**EASTON DEPARTMENT OF PUBLIC WORKS  
EASTON, MASSACHUSETTS**

**RED MILL ROAD WATER TREATMENT PLANT  
CONTRACT DPW-2022-05**

**ADDENDUM NO. 3**

**November 5, 2021**

<b>ENVIRONMENTAL</b> <b>PARTNERS</b> — An Apex Company —	NOVEMBER 2021	RED MILL ROAD WATER TREATMENT PLANT
	DPW-2022-05	ADDENDUM NO. 3
	SK-3	PAVEMENT PLAN FOR RED MILL ROAD INTERSECTION

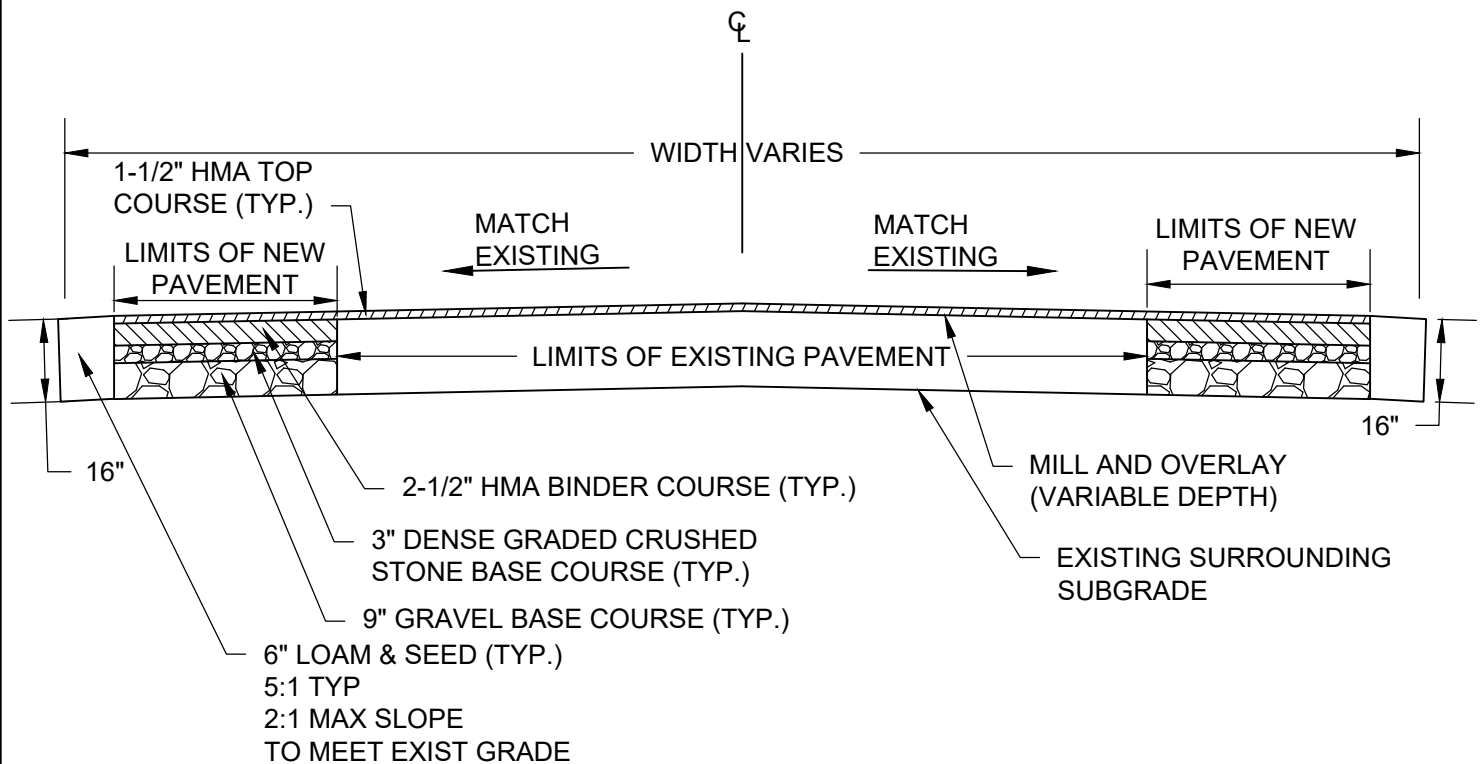
Attachment 1 – Pavement Plan for Red Mill Road Intersection SK-3

ELECTRICAL  
WTP FIRST FLOOR POWER PLAN

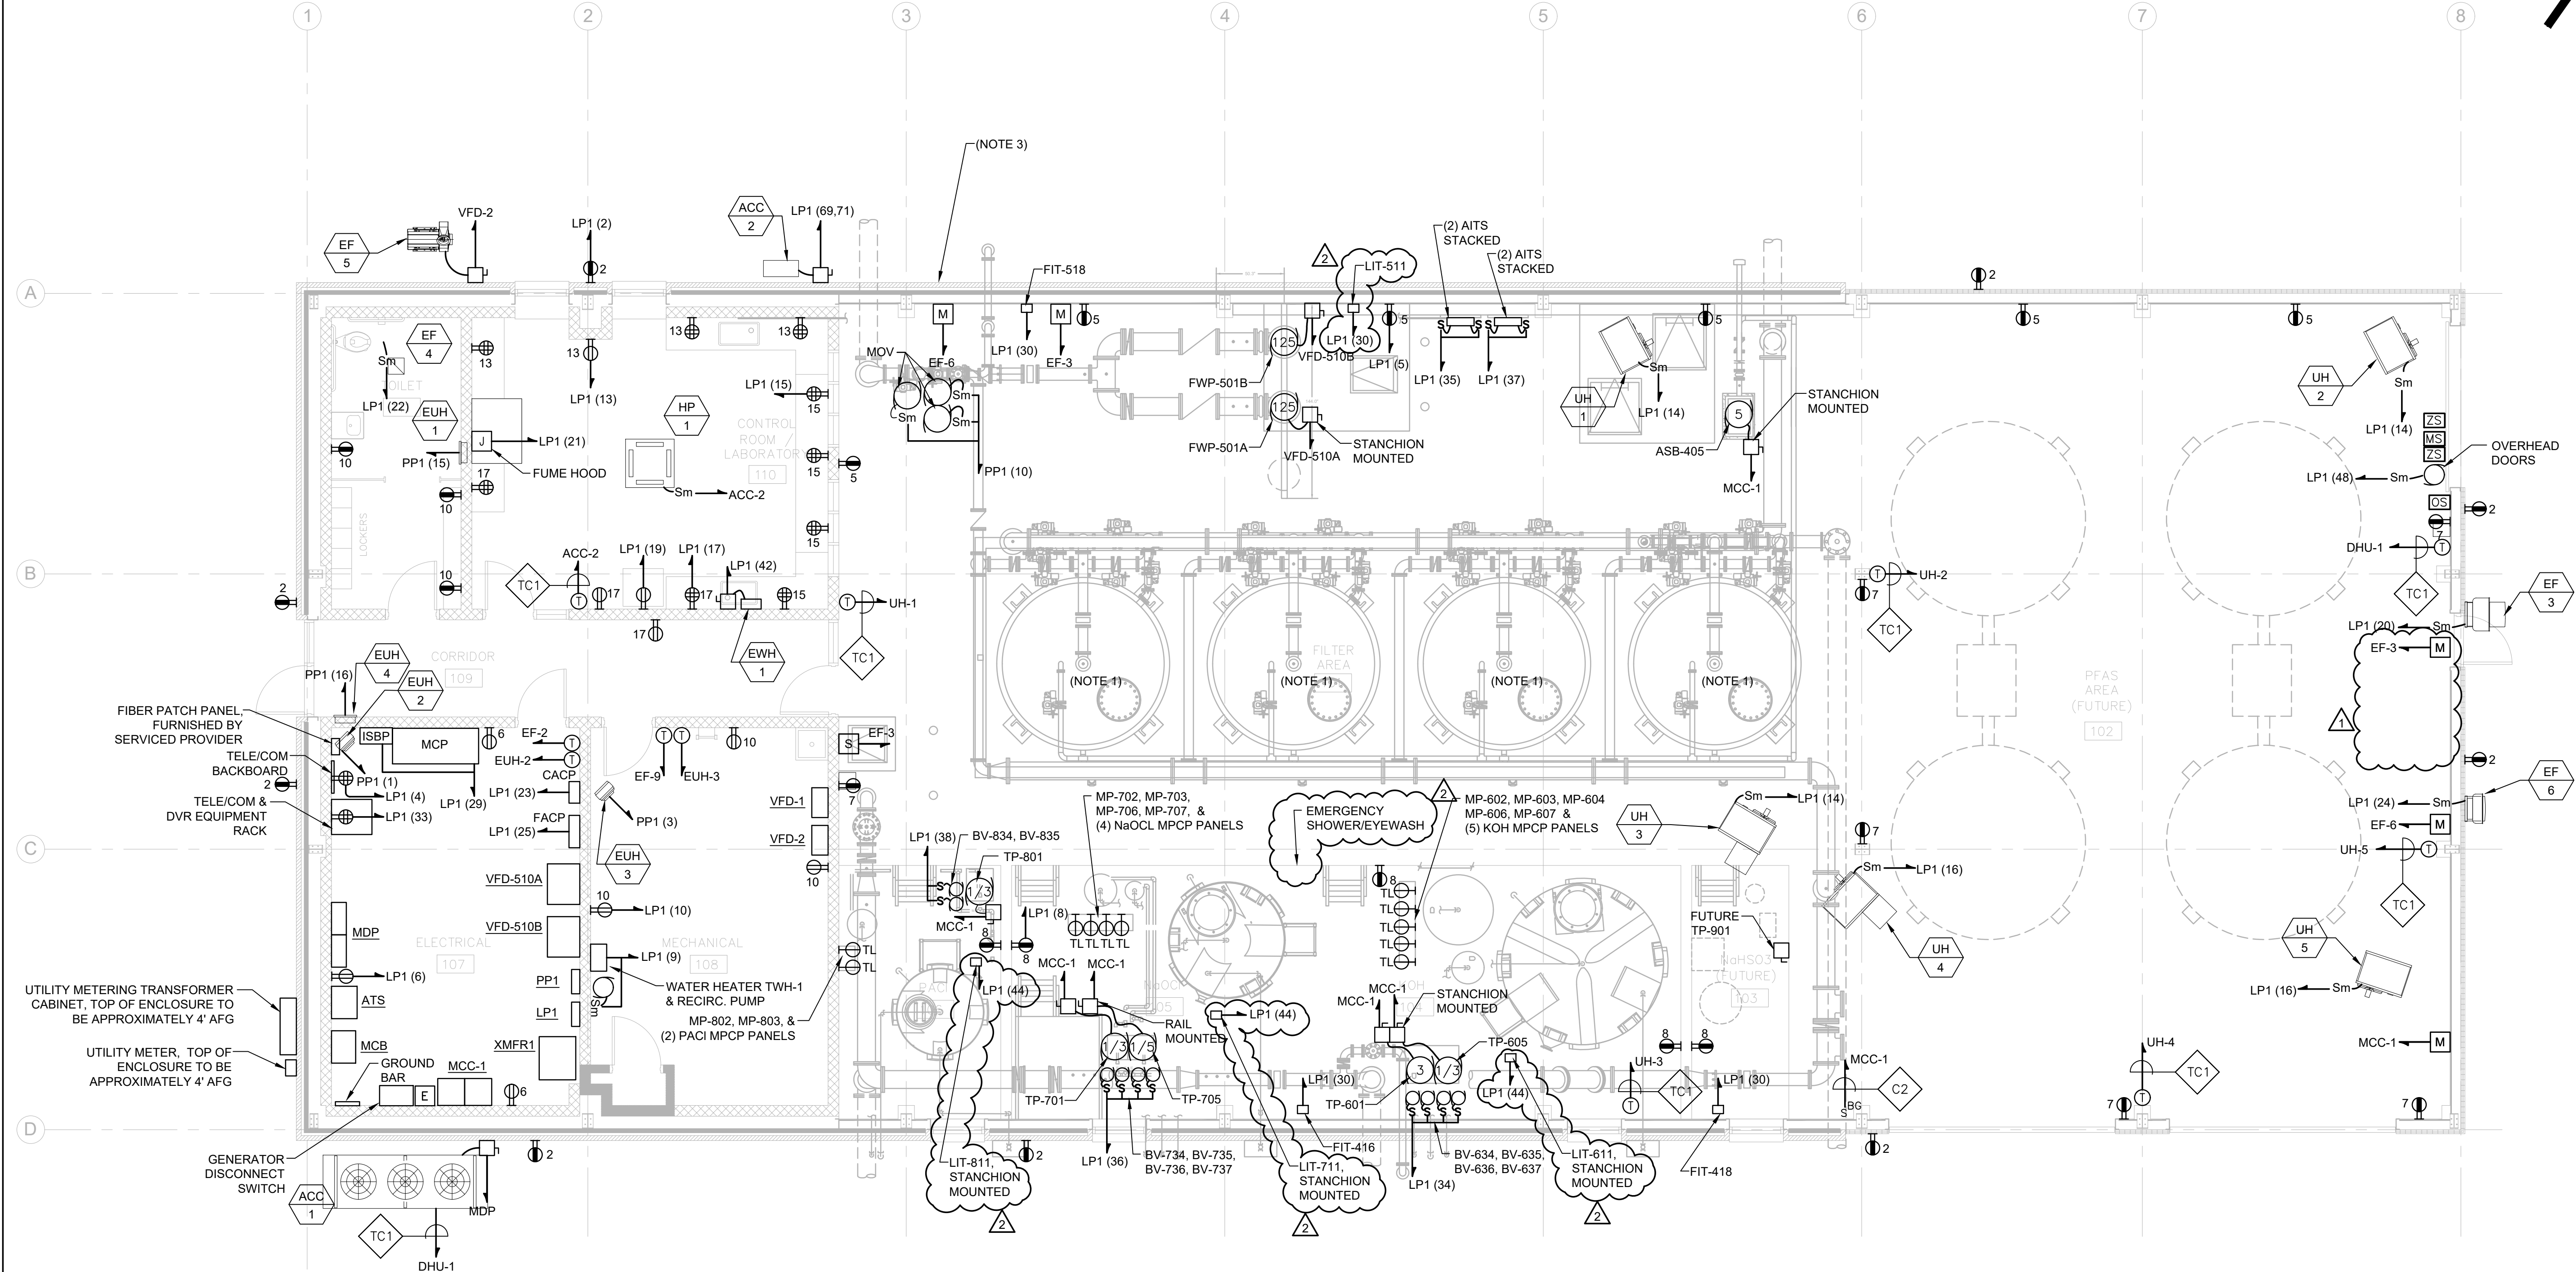
Attachment 2 – Revised Contract Drawings E-9, E-13, E-17, and E-28
